B2.1.2

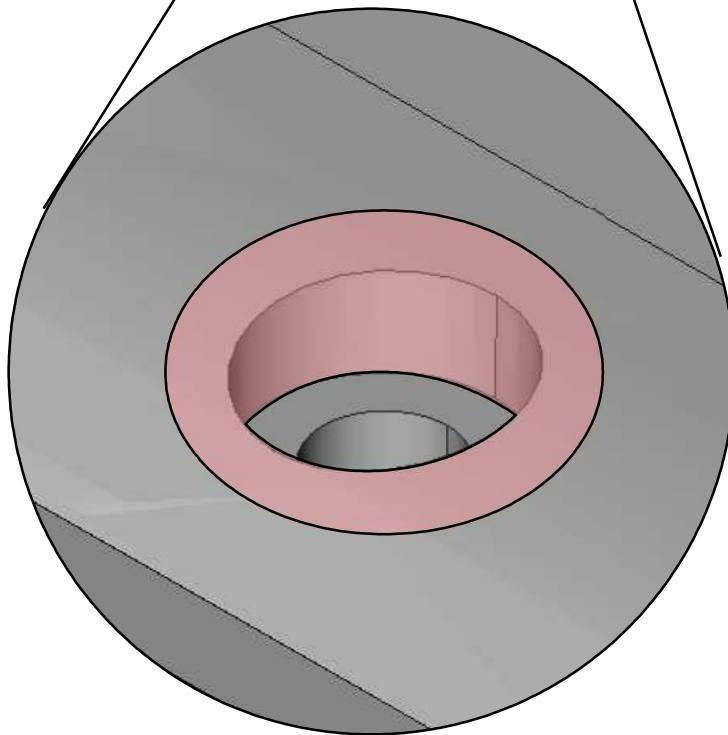
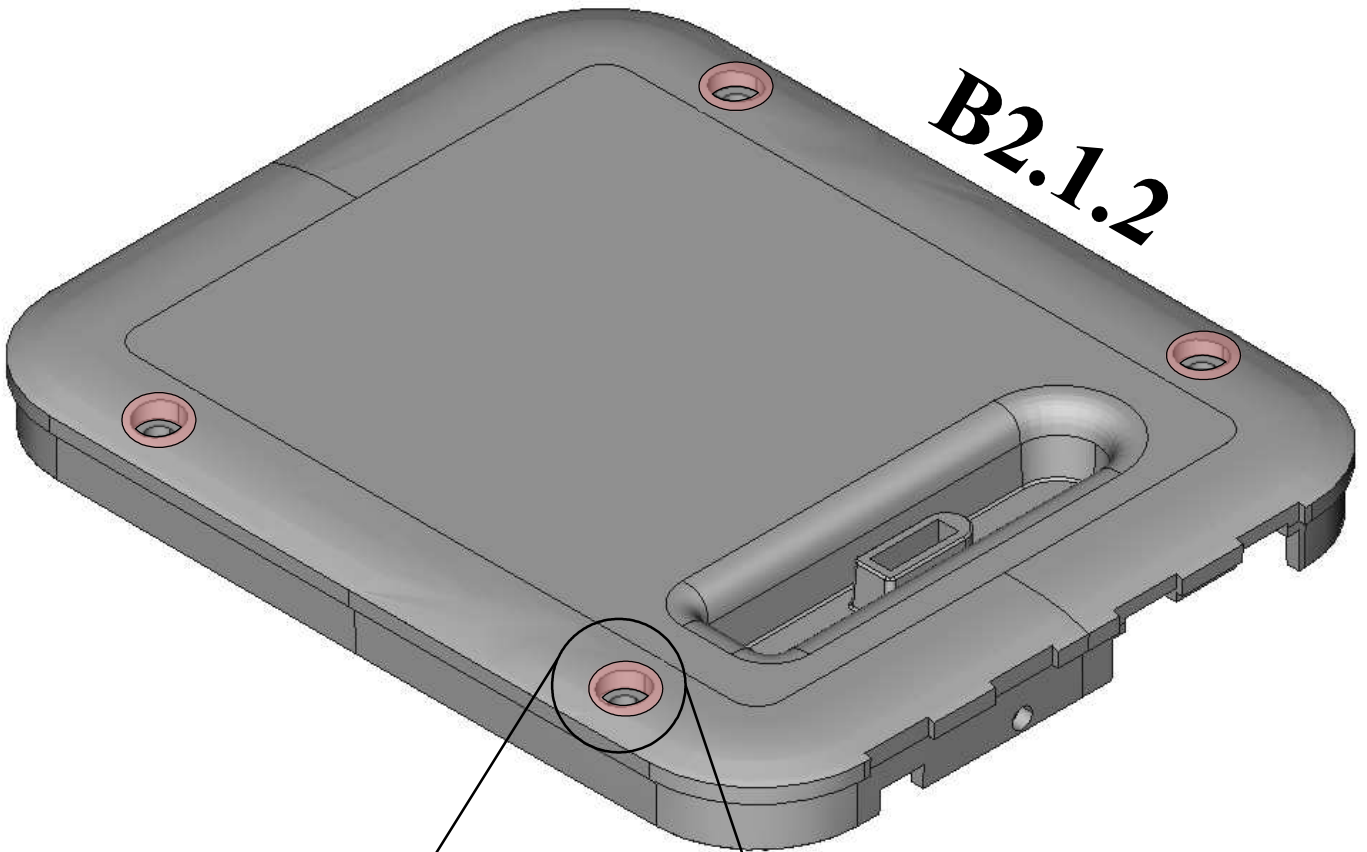
Increase counter-bore
diameter to 6mm?
